After studying the new sketch for the remodeling of the swimming pool, we approve the depth line as indicated in red pencil on the blue print.

We are enclosing the print showing one method by which we can get the swimming pool deeper in the diving section, if it meets with your approval. We are limited by the width of the footings on either side of the pool and it may be that this would be undesirable from the standpoint of use. Let me know if this meets with your approval, then we will incorporate it on the drawings.

Robinson Pool
Suggested Improvement
5-2-'45

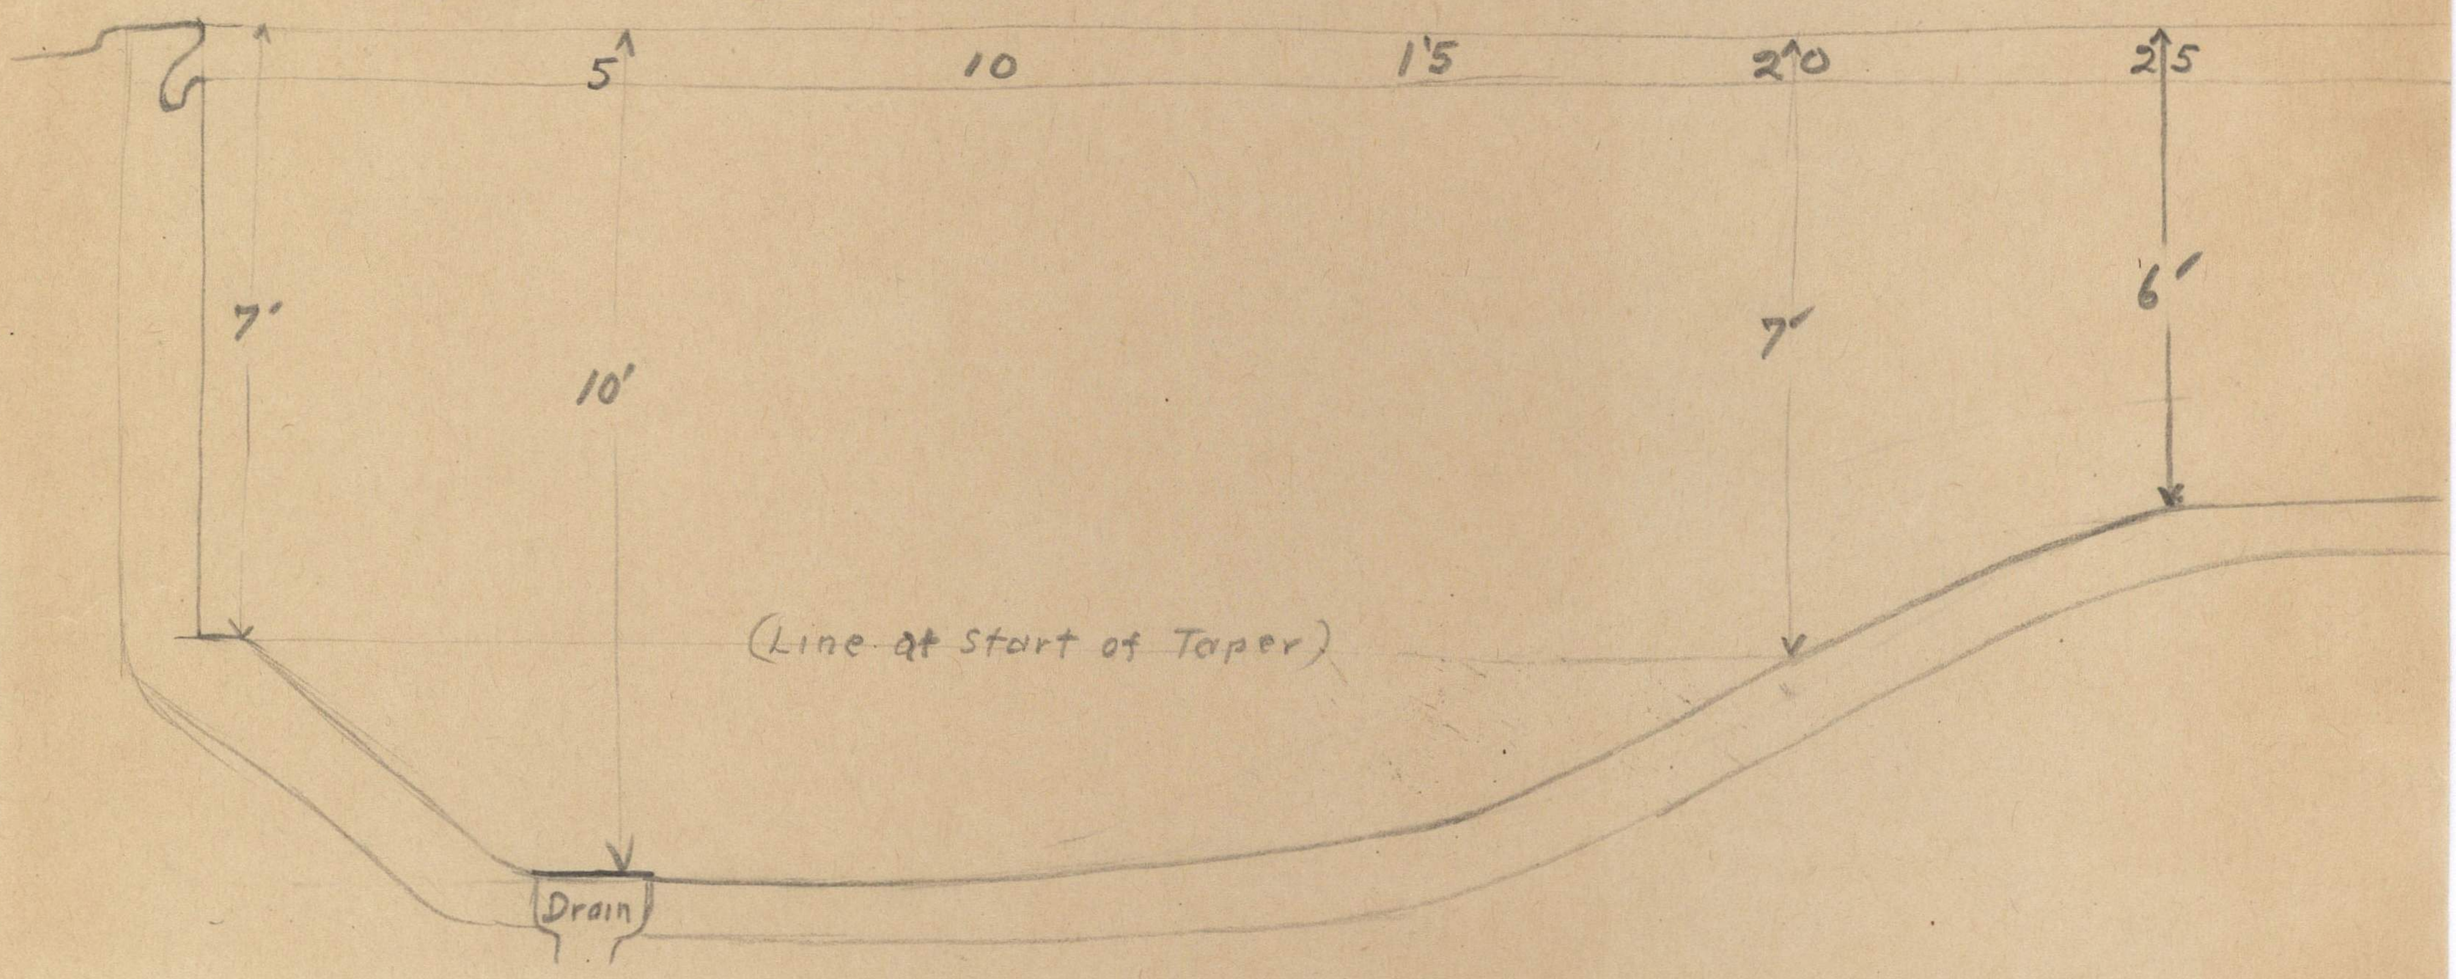
I desire to call attention to the fact that our diving board is 14 feet long, which might cause a change in location of the fulcrum.

His mention that it might be impossible to drain the pool entirely does not strike a responsive chord from this corner. It seems that there could be a raised edge around the pool thus raising the scum gutter to the floor level. This would give 9 inches more depth to the pool.

It seems that to taper the pool from about a seven foot depth to floor depth of ten feet would be advisable in order to get necessary depth for diving safety.

The degree of taper to be that necessary to miss the footing structure, thus maintaining as much all-over depth as possible.
